WATER PERMIT NO. 1748-1

SOUTH DAKOTA
WATER PERMIT NO. 1748-1

REPORT ON
WATER PERMIT APPLICATION NO. 1748-1
Daniel A. Brooks
August 2, 2001

**RECOMMENDATION OF CHIEF ENGINEER FOR WATER PERMIT
APPLICATION NO. 1748-1, Daniel A. Brooks**

STATE		PROJECT <u>DAN BROOKS</u>		
BY <u>T. Ver Helst</u>	DATE <u>7/18/01</u>	CHECKED BY	DATE	JOB NO.
SUBJECT <u>WATER RIGHTS DATA</u>				SHEET <u>1</u> OF <u>1</u>

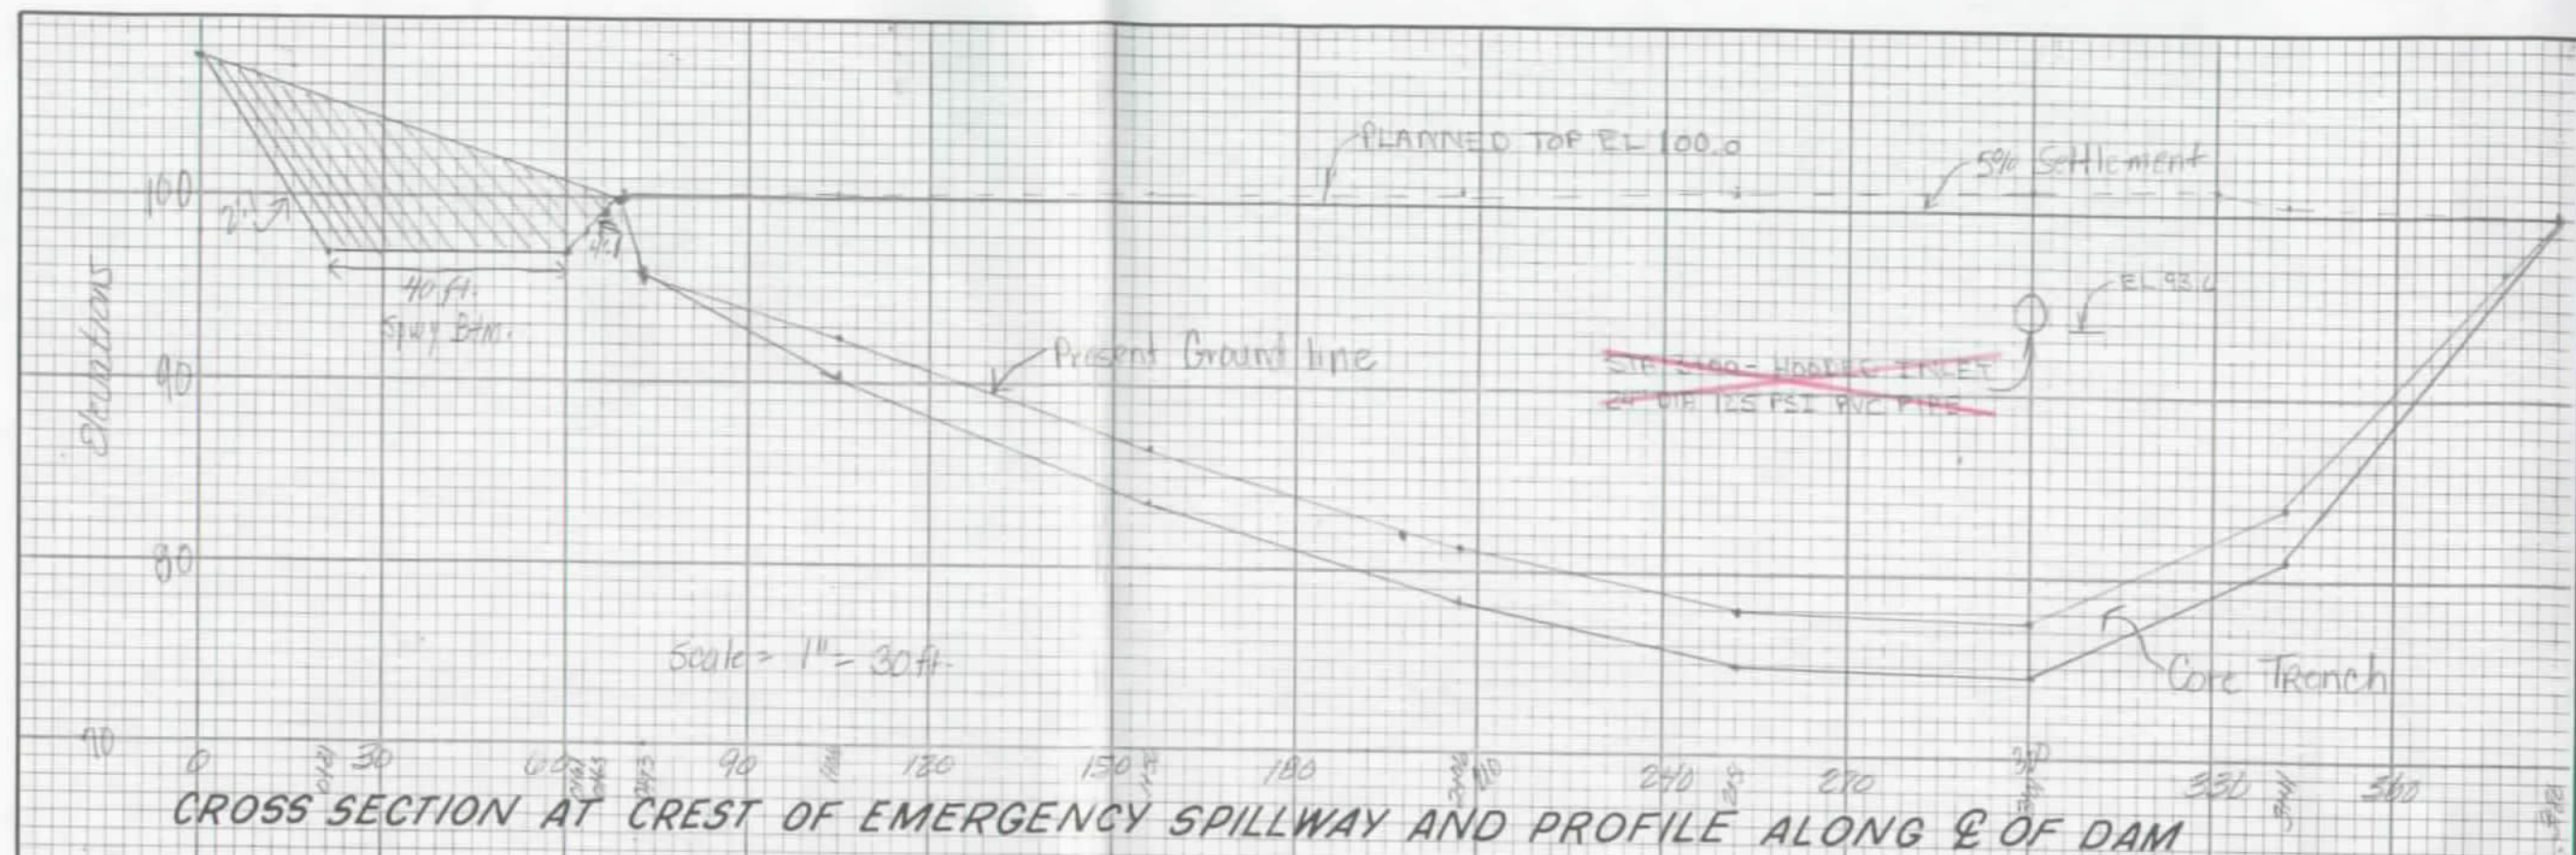
Note: Will use planimeter method due to significant pool area from side tributary.

DENR Dam Safety Criteria:

$$\text{Spillway Design Flood} = 43.7 \text{ ac-ft} \times 19.5' = 852 < 3000 \text{ Use 25yr-24hr}$$
